Planning Commission

Regular Meeting Agenda
February 12, 2024 | 6:30 PM
Peachtree City City Hall

SUBJECT: Conceptual Site Plan, Highway 54 West Development, 1941 W HWY 54

Parking Standards

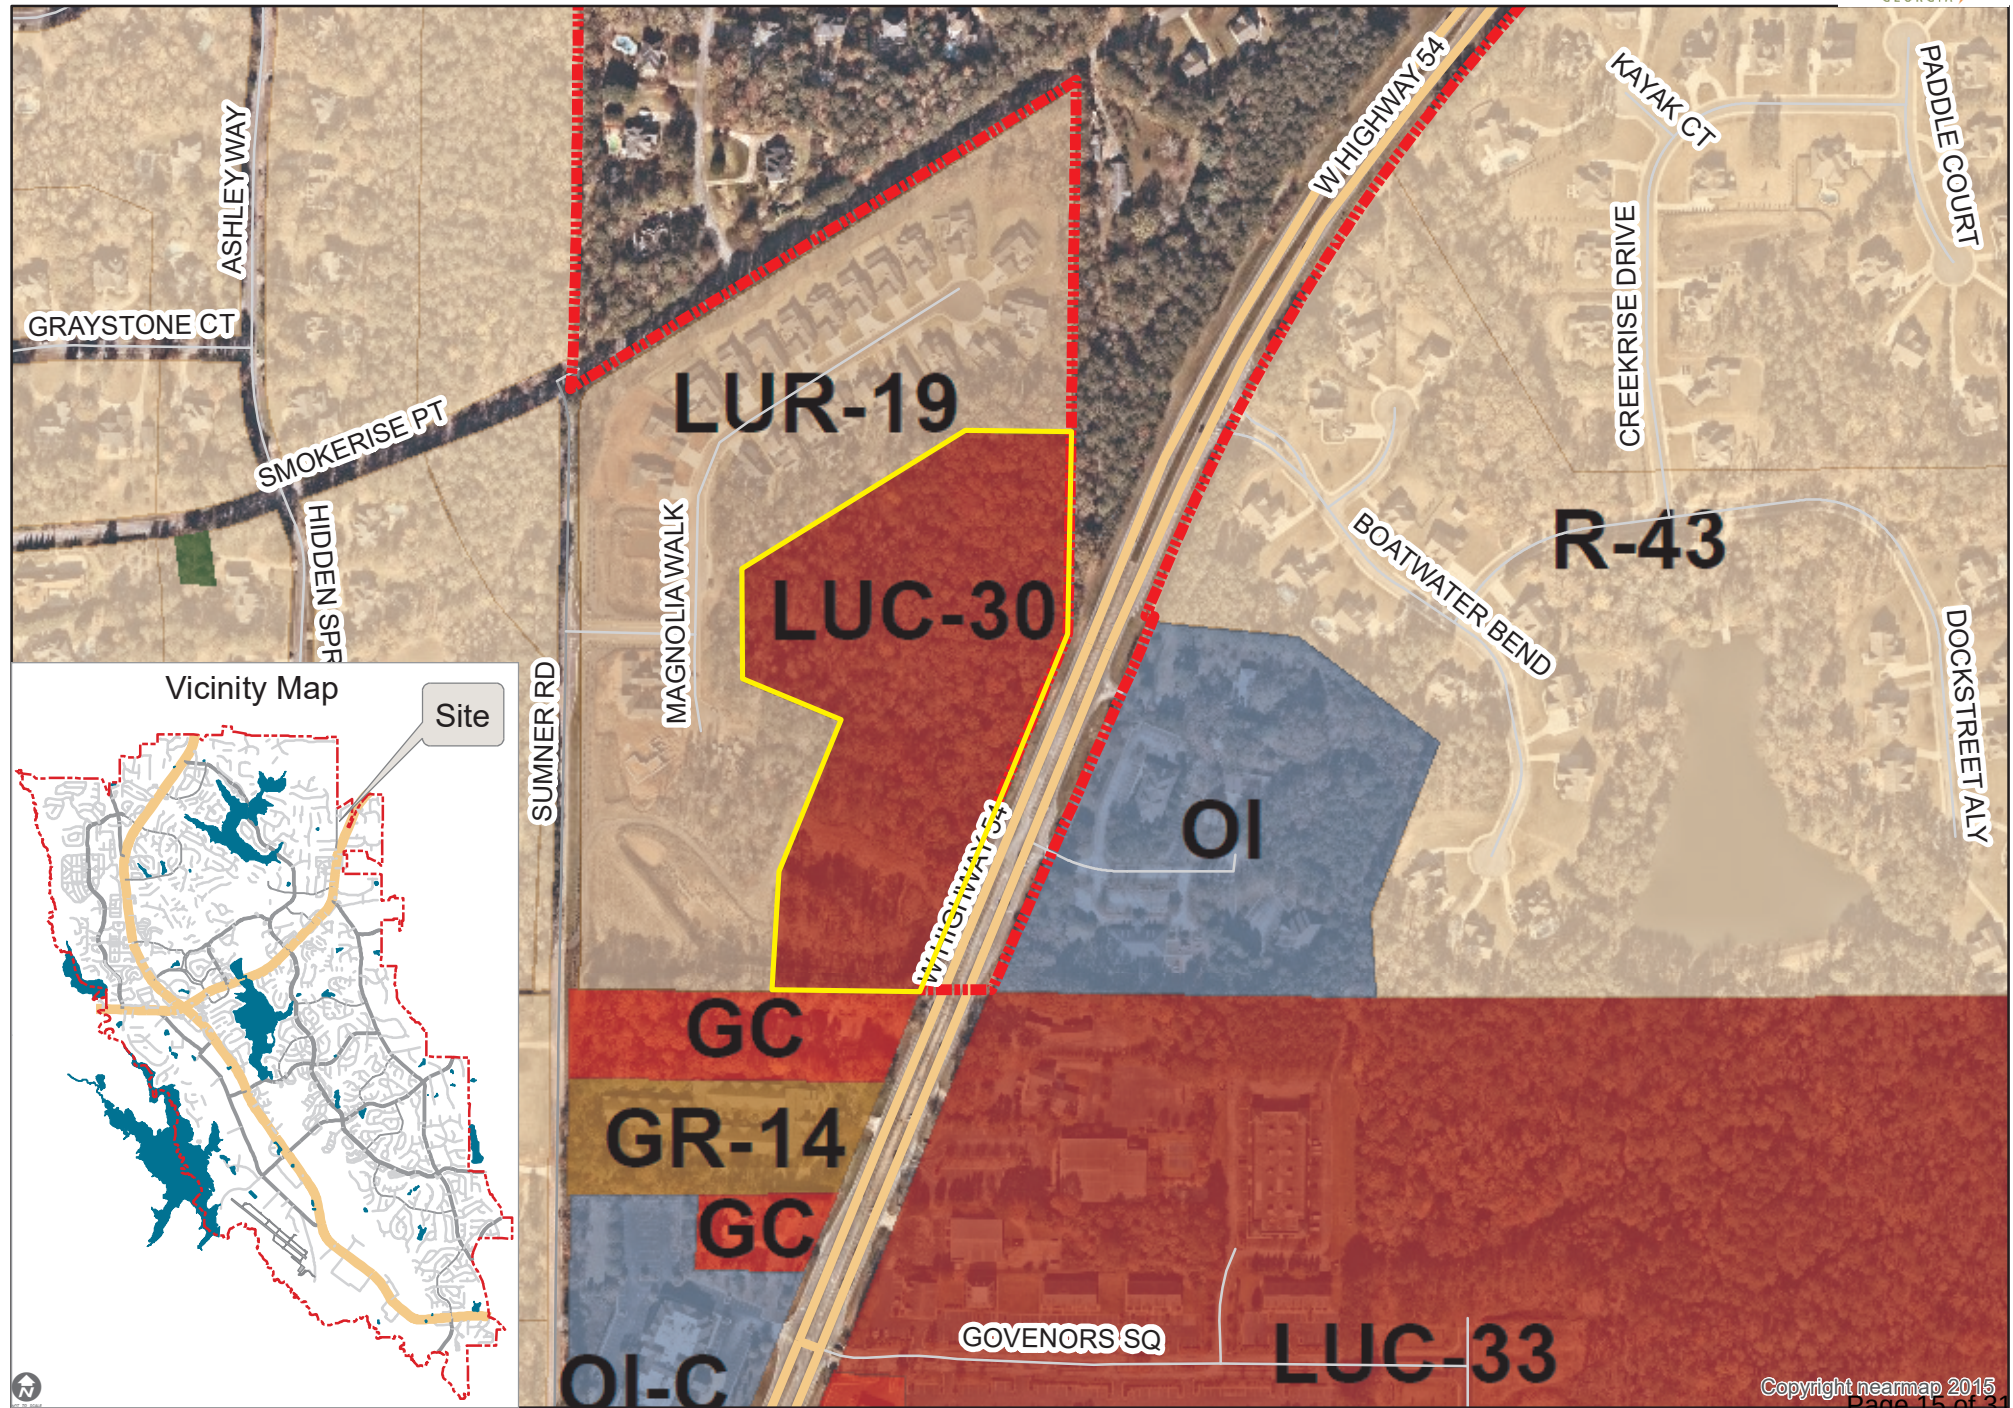
- Address the three (3) dead-end parking lots. While this is not specifically a life-safety code concern, please consider how vehicles can turn around or circulate through the site when the lots are full.
- Add golf-cart parking locations. The recommended rate was about 5 spaces per retail building. Some of the over-parked automobile spaces may be converted to golf-cart spaces, but the number of automobile spaces must meet the minimum required by the ordinance. In addition, the connection to the existing off-site path should be more clearly shown on the plan.
- Commissioners requested information on the GDOT driveway study. The City understands that the access point will be controlled by GDOT, but the Commissioners are interested in the information when it is available
- If the site is designed to preserve old-growth trees, show these tree locations on the plan.

The original conceptual site plan included three dead-end parking lots that the Planning Commission requested be evaluated for better circulation should the parking lots be full. The revised plan eliminates all dead-end parking lots.

In addition, the Planning Commission requested clarification on the path connection to the existing path in the Smokerise Corners subdivision. This connection is shown on the revised conceptual site plan, between two (2) of the three (3) dedicated golf-cart parking areas.

The revised site plan reduces automobile parking spaces from 367 to 332 and adds 30 dedicated golf-cart parking spaces. A summary of the parking requirements and proposed parking is provided in the table below:

LANDSCAPE PLAN

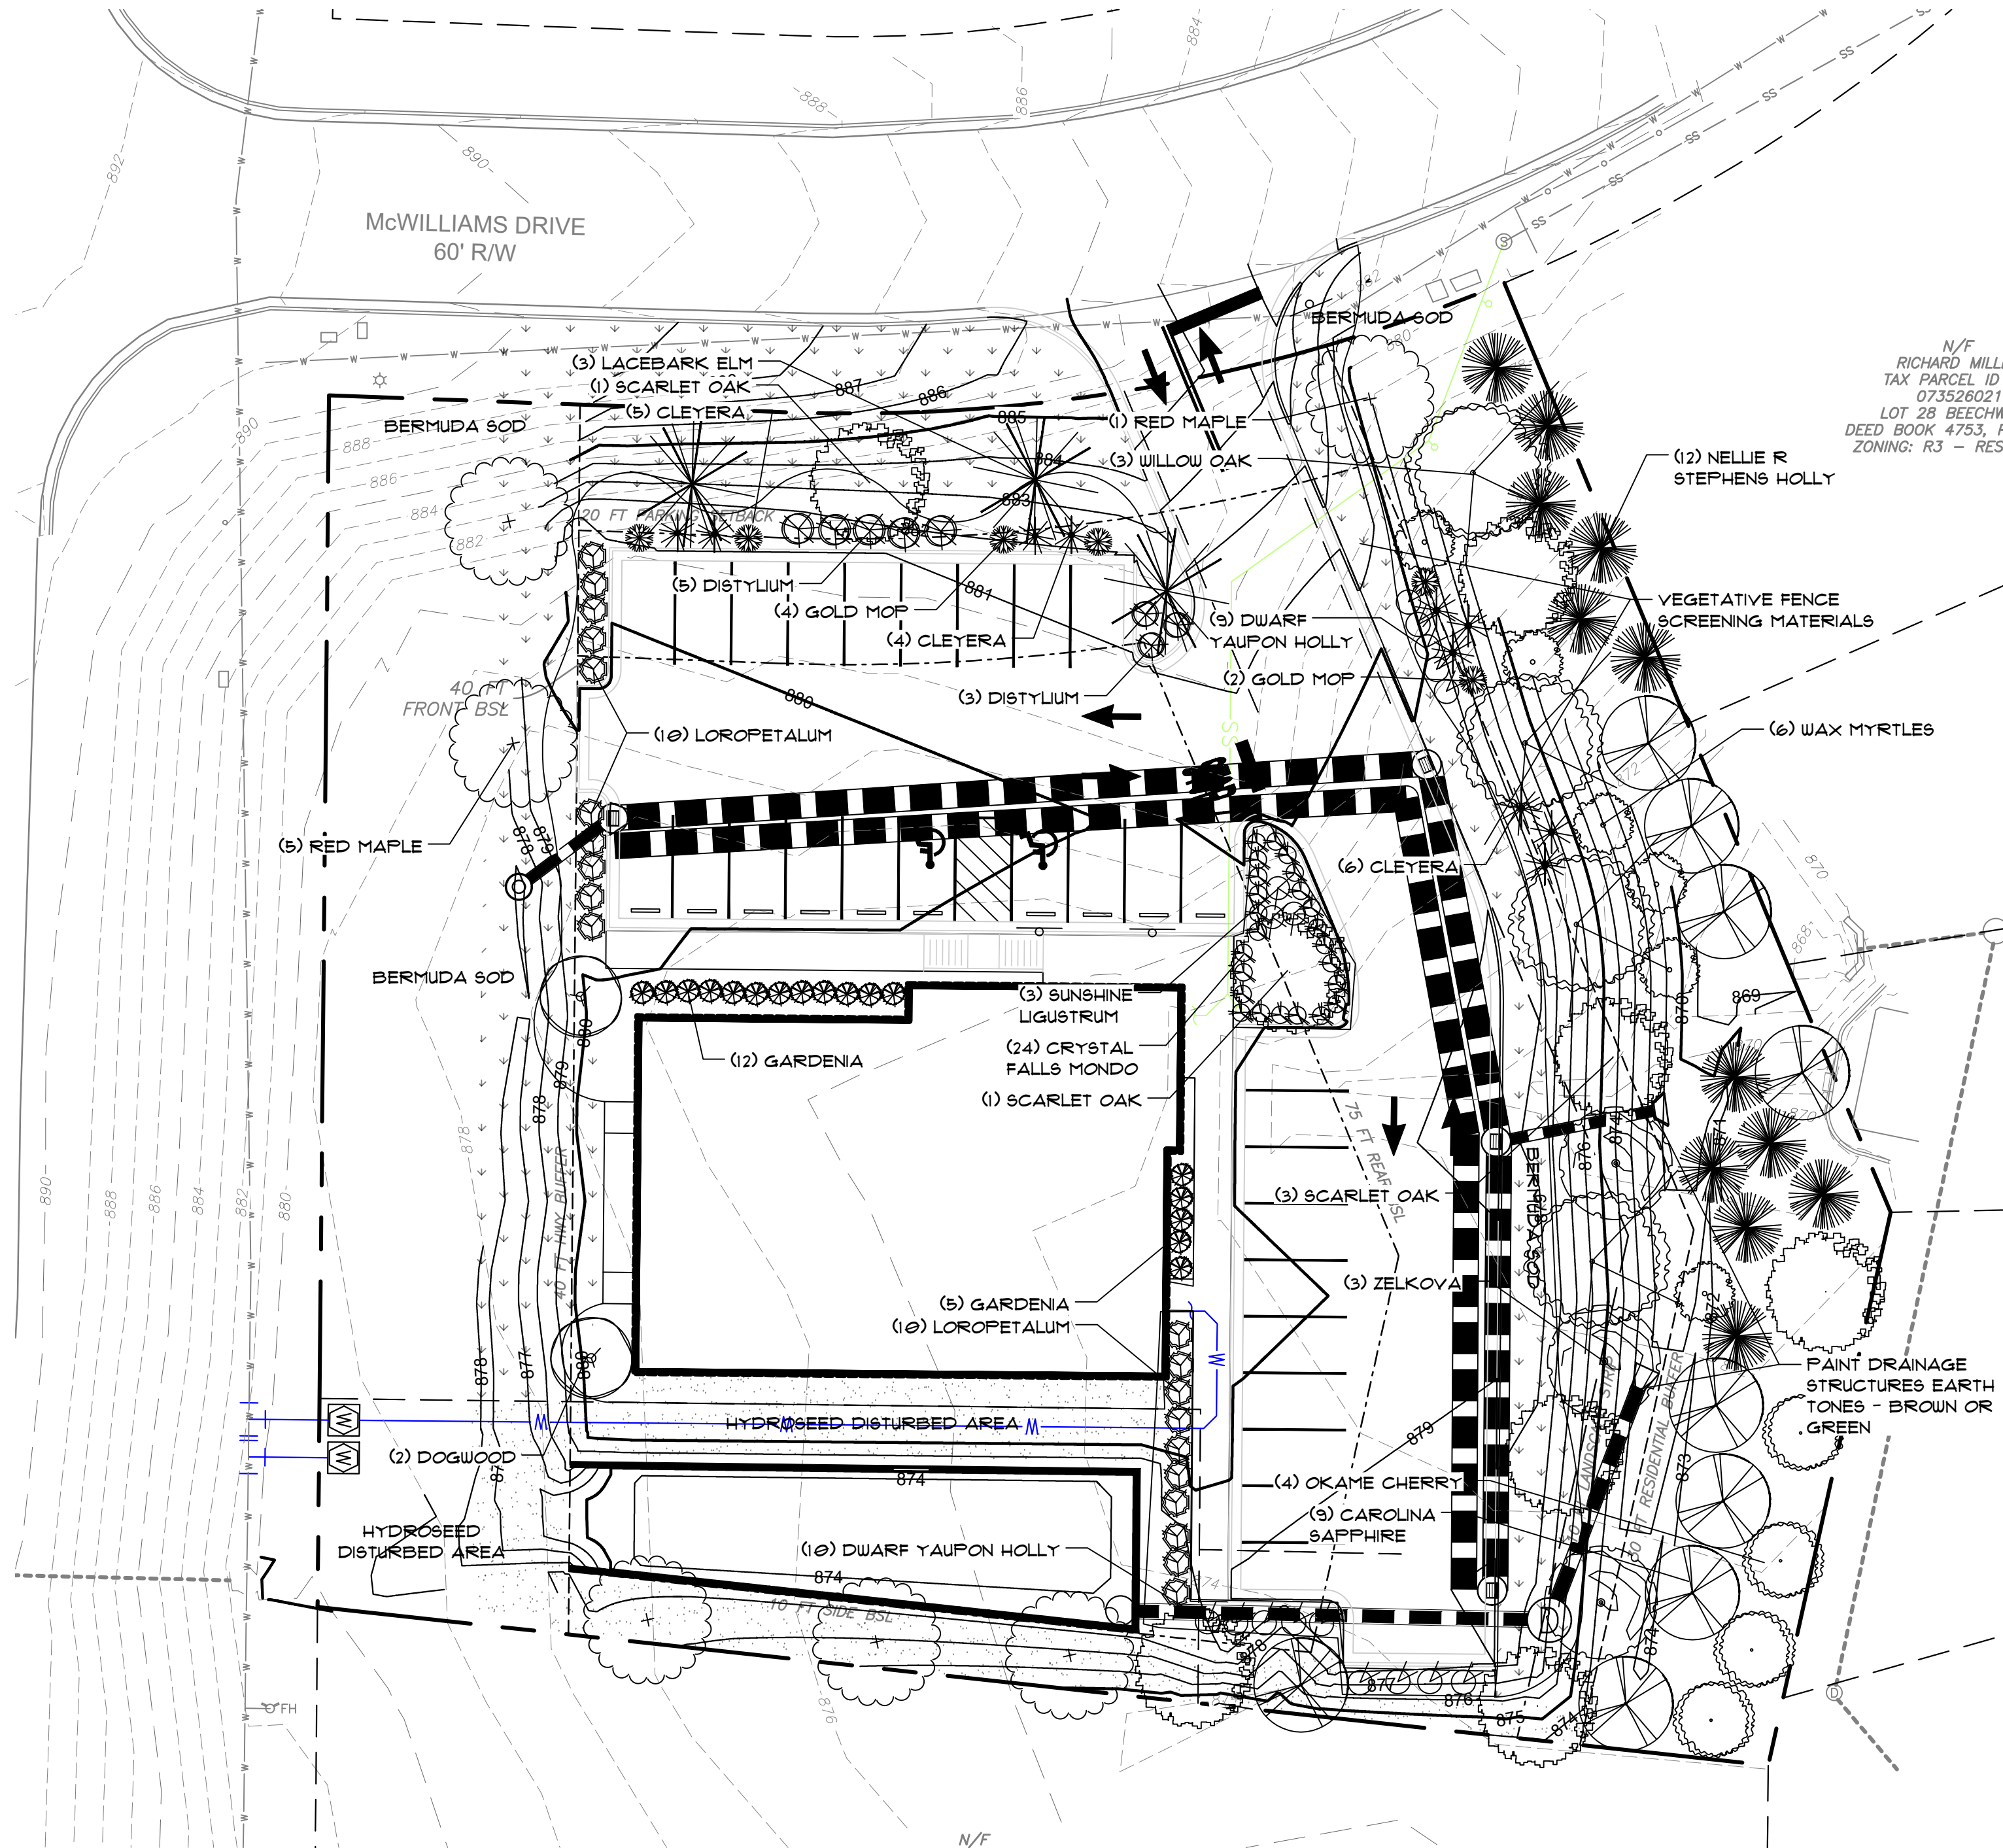
Since the property is located along Highway 74, a major thoroughfare, a 60-foot tree-save buffer would typically be required. During the conceptual site plan process, a buffer reduction from 60 feet to 40 feet was approved. As a result, the developer is required to install 20% more of the caliper inches of trees required by the landscape ordinance.

Per section 1110(e) of the Land Development Ordinance (LDO), undisturbed tree-save areas may be used to offset the number of caliper inches required on a site. No tree-save areas were identified on the plan. In addition, the applicant is not requesting to use the Tree Fund alternative compliance option to meet the caliper inch requirement. The proposed plan meets the caliper inch requirement (see table below).

In addition to the tree-save buffer reduction, a variance was granted for the 75-foot transitional yard requirement between a non-residential and a residential zoning district. A condition of the variance is for additional evergreen landscaping to be added between the proposed parking lot and the adjacent residential lots to provide a visual buffer. Three species of evergreens are proposed for the buffer at a planting size of 8-10 feet. The evergreens are located throughout the buffer area, creating a continuous visual screen.

BUFFER REDUCTION ADD 20% ADDITIONAL INCHES REQUIRED
REQUIRED ADDITIONAL 3" CAL TREE INCHES : 60 X 20% = 12 TOTAL
REQUIRED 3" CAL TREES = 12" OR 24 TREES

BUFFER REDUCTION ADD 20% ADDITIONAL INCHES REQUIRED
REQUIRED ADDITIONAL 2" CAL TREE INCHES : 40 X 20% = 8 TOTAL
REQUIRED 2" CAL TREES = 48" OR 24 TREES

Cul-de-sacs

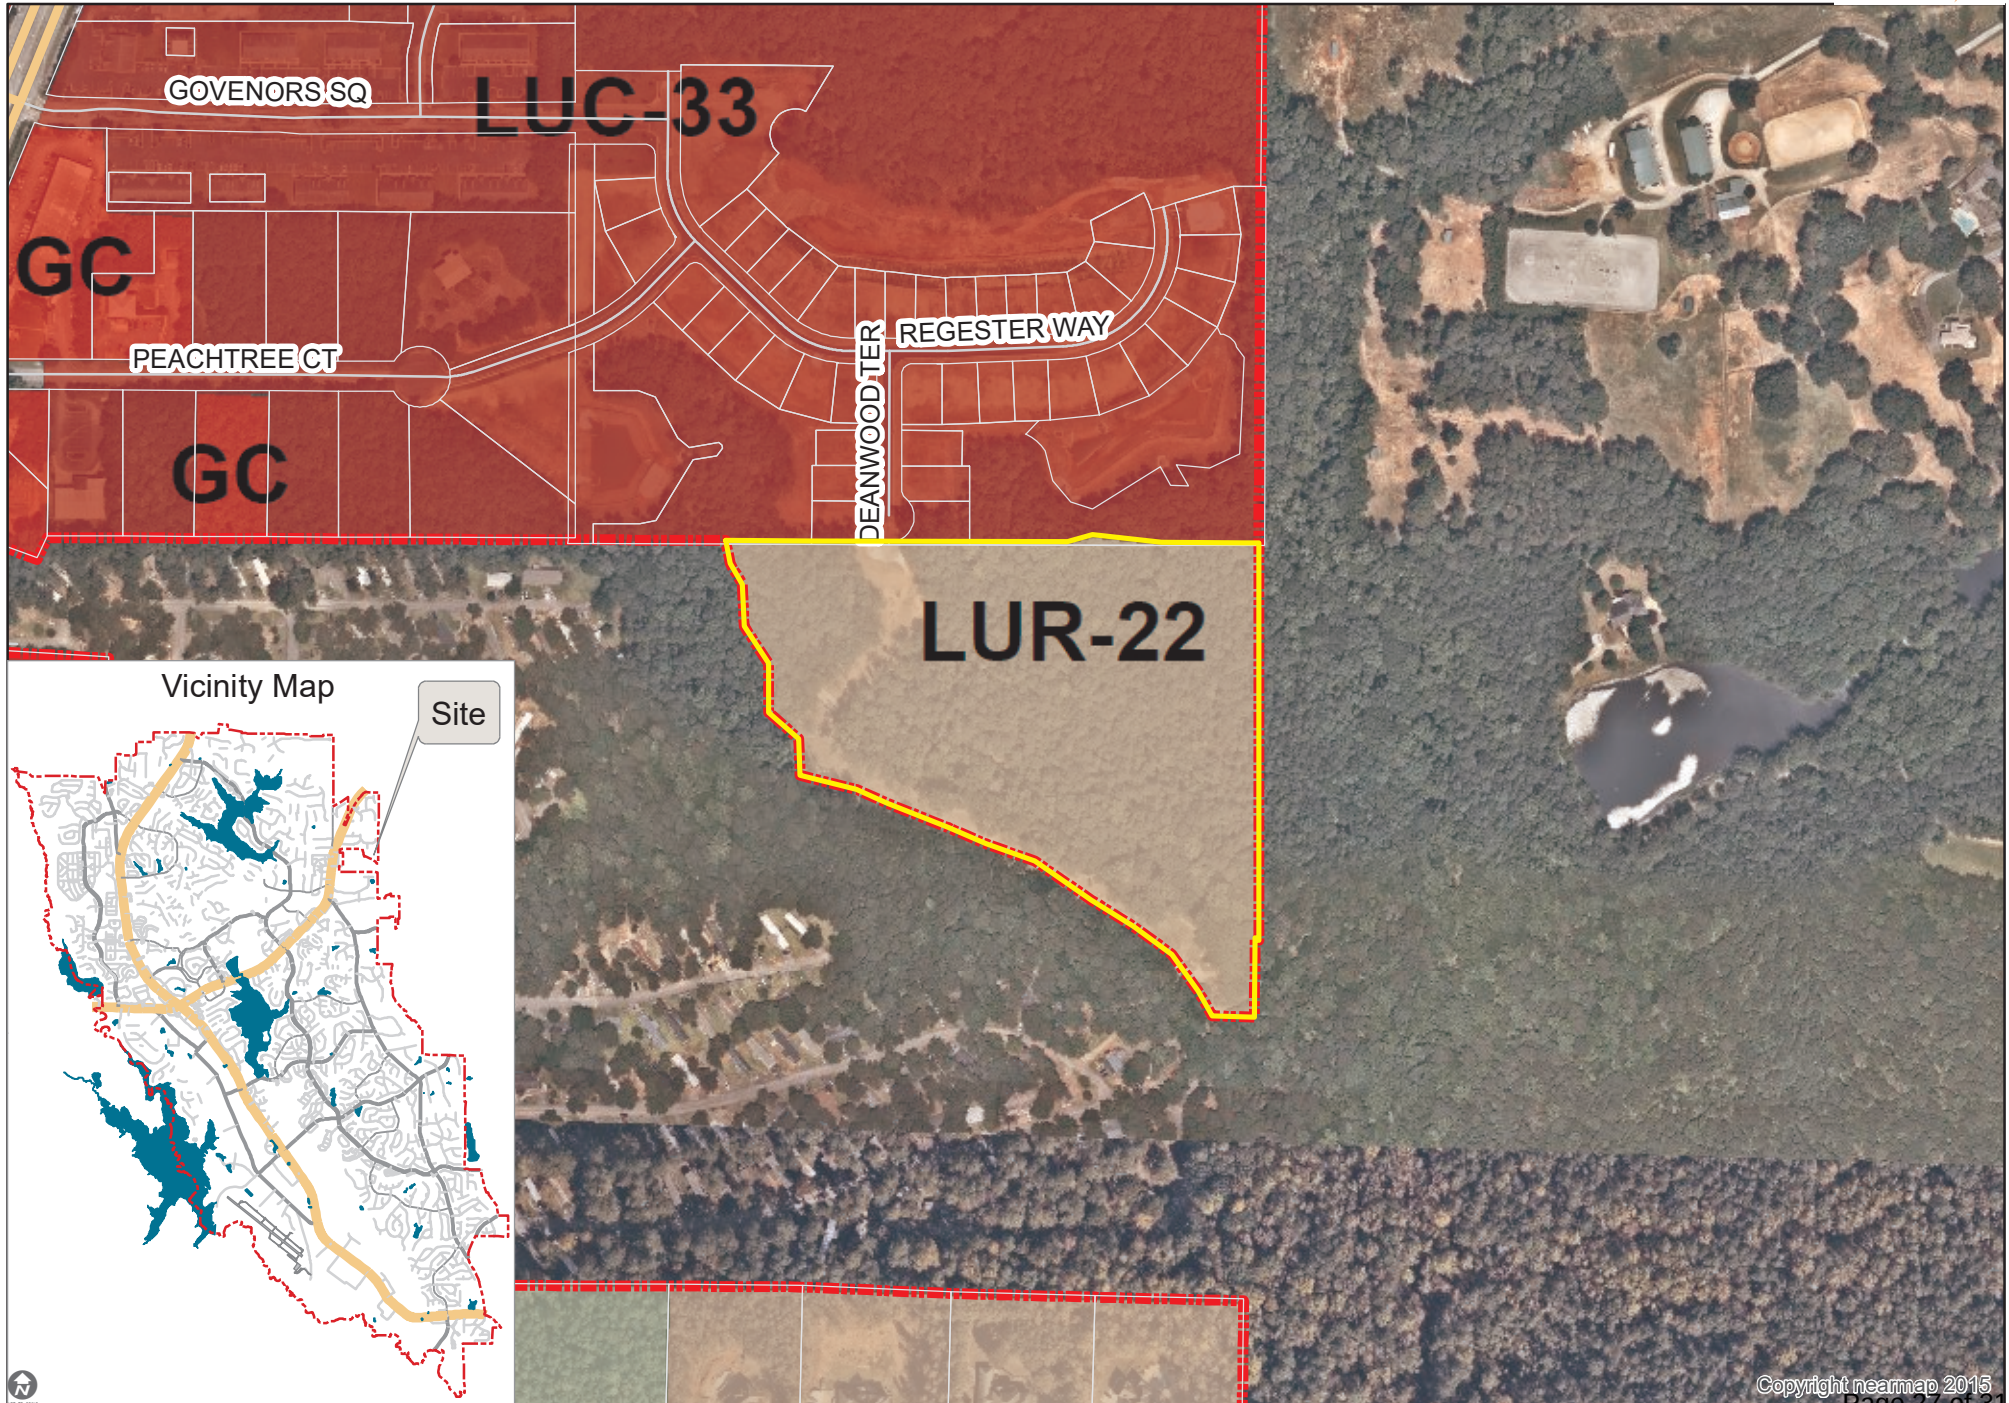
The LDO states that cul-de-sacs should not be greater in length than 1,200 feet. With the proposed extension to Deanwood Terrace, the total length of the cul-de-sac will be approximately 970 feet, meeting the requirement.
